HISTORIC AND DESIGN REVIEW COMMISSION

July 15, 2020

HDRC CASE NO: 2020-302
ADDRESS: 619 BARBE ST
LEGAL DESCRIPTION: NCB 2877 BLK 2 LOT 14
ZONING: RM-4,H
CITY COUNCIL DIST.: 1
DISTRICT: King William Historic District
APPLICANT: Ryan Alton/NEW HORIZONS ARC LLC
OWNER: NEW HORIZONS ARC LLC
TYPE OF WORK: Installation of front yard fencing
APPLICATION RECEIVED: June 18, 2020
60-DAY REVIEW: Not applicable due to City Council Emergency Orders
CASE MANAGER: Stephanie Phillips

The applicant is requesting a Certificate of Appropriateness for approval to install a new cattle panel-style front yard fence measuring three feet in height, to include a pedestrian gate and driveway gate.

Site Map and survey of 619 Barbe:

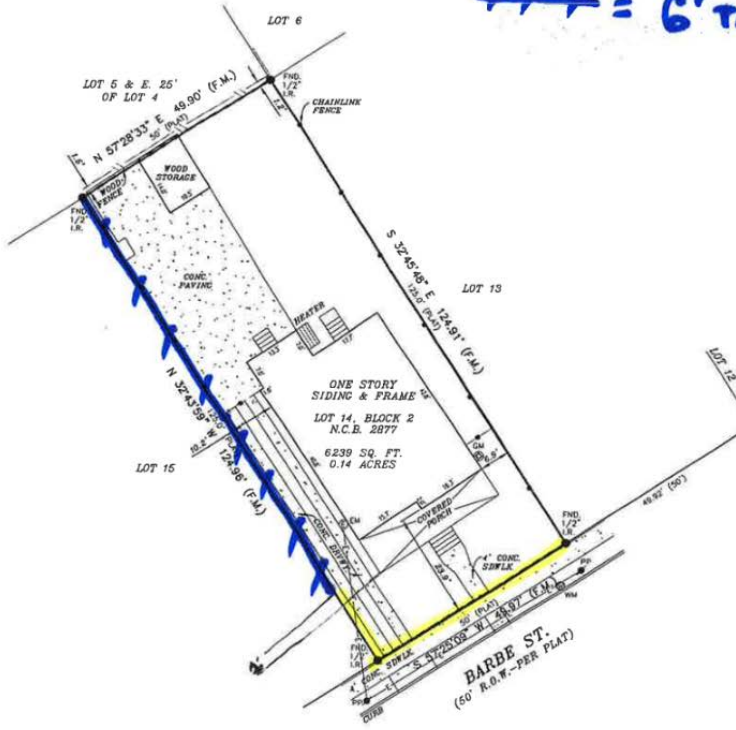
- b. FENCING: LOCATION – The applicant is requesting approval to add a fence along the left and front side of the home. The fence is requested to be three feet tall with a wood post and cattle panel design. The fencing will include a driveway gate and a pedestrian gate. The driveway gate will run along the sidewalk versus turning to meet the home. According to the Historic Design Guidelines, fences should be introduced in locations that historically featured them, or if new, in locations where fencing is appropriate for the district. Staff generally finds fencing in this location to be appropriate. While front gates along the sidewalk are typically not recommended, the driveway runs very close to the front of the home and the structure features a full width front porch. Based on these site-specific conditions, staff finds a driveway gate acceptable.

- c. FENCING: MATERIAL – As noted in finding b, the fence is proposed to be constructed of wooden posts and cattle pattles. According to the Historic Design Guidelines, fences should feature designs and materials that are compatible with the historic structure or historically common in the specific historic district. Where fencing is present or common in King William, the material is most commonly wrought iron or wood picket. Staff does not find the proposed material appropriate for the district.

- i. That the fencing material be modified to be more in keeping with the fence styles that are characteristic of the district, such as wood picket or wrought iron, as noted in finding c. The applicant is required to submit an updated design to staff prior to the issuance of a Certificate of Appropriateness.
- ii. The final construction height of an approved fence may not exceed the maximum height as approved by the HDRC at any portion of the fence. Front yard fences shall not exceed four (4) feet in height at any point. Additionally, all fences must be permitted and meet the development standards outlined in UDC Section 35-514.
